TRANS/WP.29/GRSP/2001/16
4 September 2001

World Forum for Harmonization of Vehicle Regulations (WP.29)

Working Party on Passive Safety (GRSP)

PROPOSAL FOR DRAFT 04 SERIES OF AMENDMENTS TO REGULATION No. 44
(Child restraints)

Figure 0a

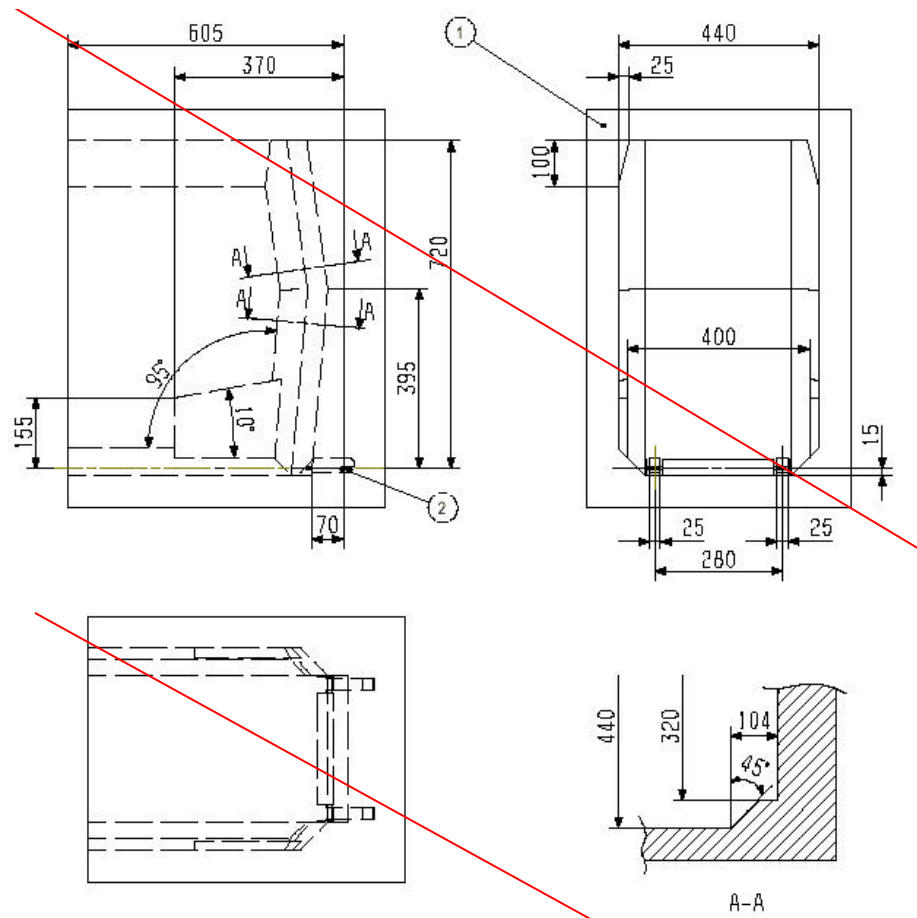
Insert new paragraphs 2.2.8. to 2.31., to read:

- "2.28. ISOFIX attachment means one of the two connections, fulfilling the requirement of paragraph 6.3.2. of this Regulation, extending from the ISOFIX child restraint system structure, and compatible with an ISOFIX low anchorage.
- 2.29. ISOFIX child restraint system means a ~~ISOFIX~~ child restraint system ~~intended~~ which has to be attached to an ISOFIX anchorage system.
- 2.30. Seat bight means the area close to the intersection of the surfaces of the vehicle seat cushion and the seat back.
- 2.31. Vehicle seat fixture (VSF) means a fixture, complying to dimensions shown in figures 1 and 2 of annex 7 appendix 2 of Regulation No. 16 0a and 0b, used by a child restraint manufacturer to determine the appropriate dimensions of an ISOFIX child restraint system and the location of its ISOFIX attachments ."

Figure 0c

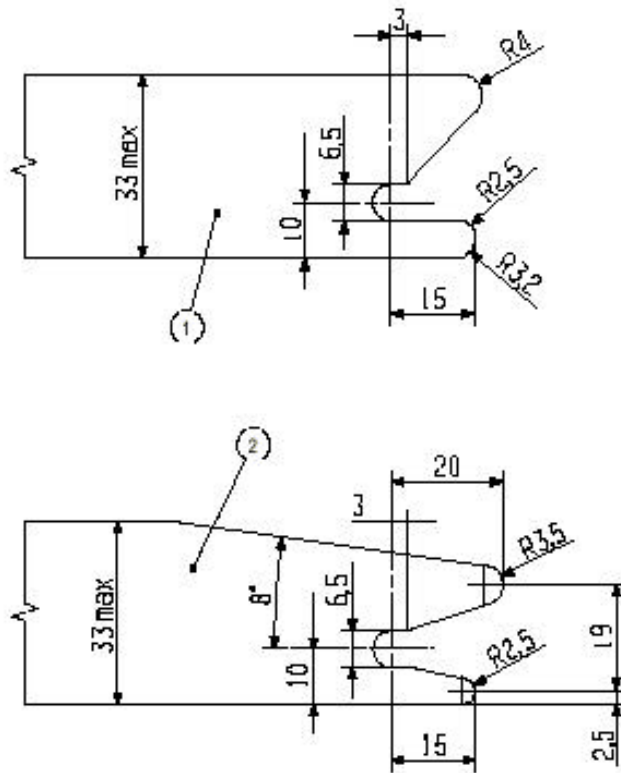
Attachments to anchorages may be according to examples shown in Figure 0c, or other appropriate designs that are part of a rigid mechanism having provision for adjustment, the nature of which is determined by the child restraint system manufacturer.

Figure 0d

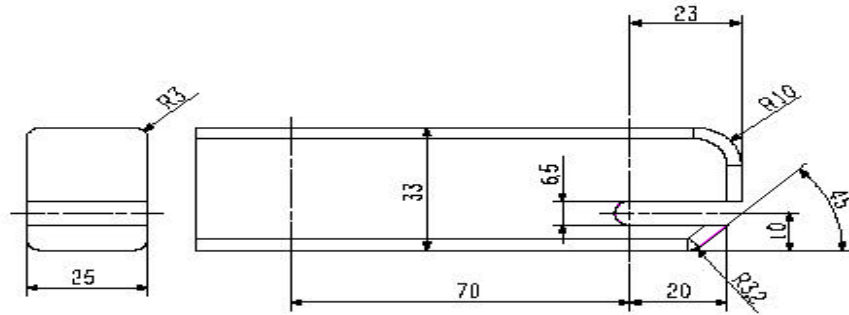
Dimensions for the portion of the ISOFIX child restraint system connector that engages the anchorage bar must not exceed the maximum dimensions given by the envelope in Figure 0d

Figure 3

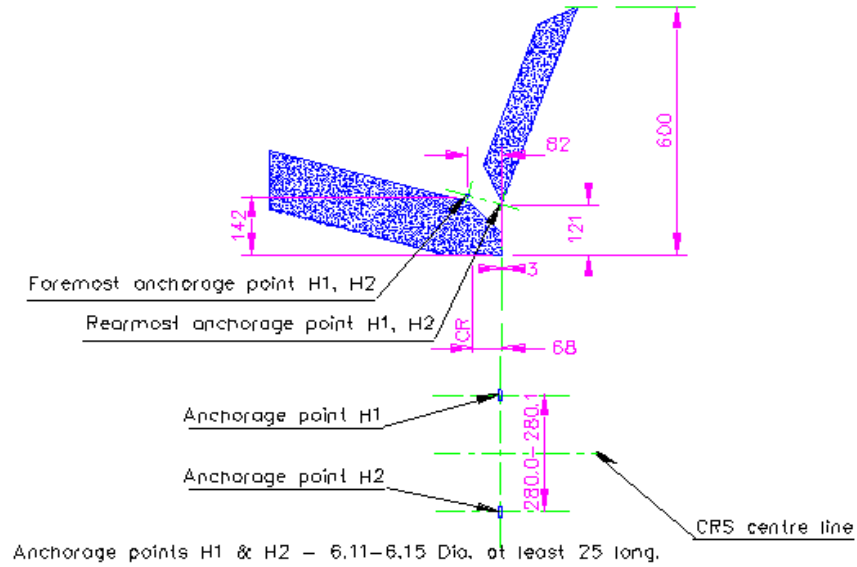
Insert a new figure 3, to read:

" **2.3. For child restraints using ISOFIX attachment, points H₁ and H₂.**"

"3. Anchorages A, B **and/or H₁ H₂** and D shall be used (.... no change....) upper anchorage.

4. Anchorages A, B **and/or H₁ H₂**, E and F shall be used (... no change...) upper anchorages."

Annex 21,

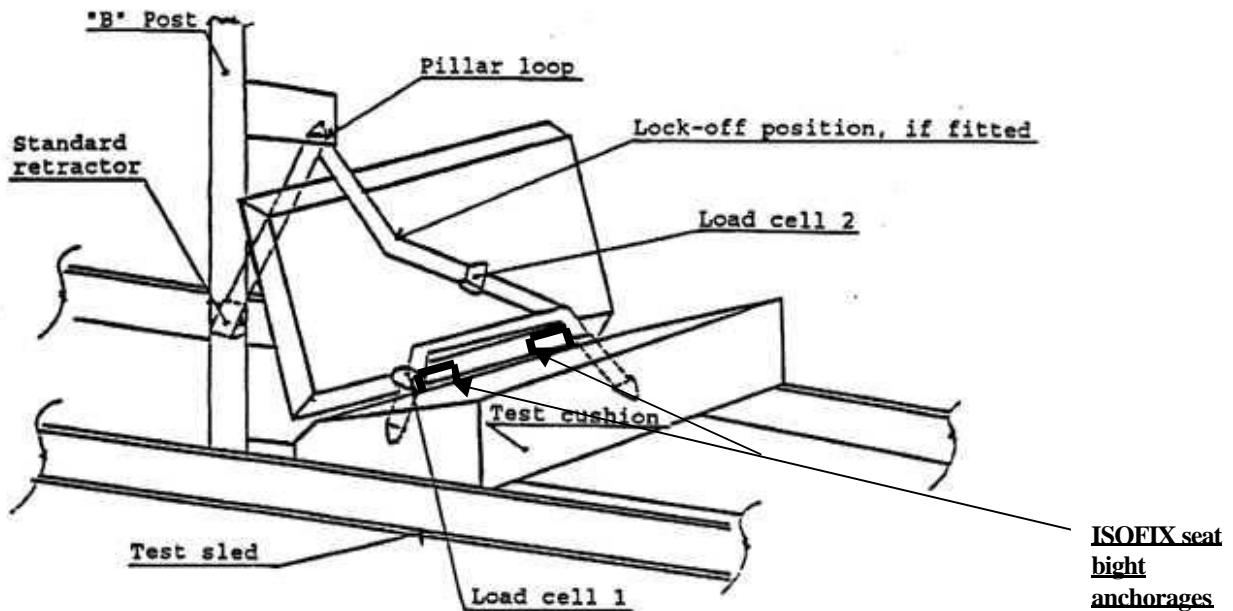
The figure, amend to read:
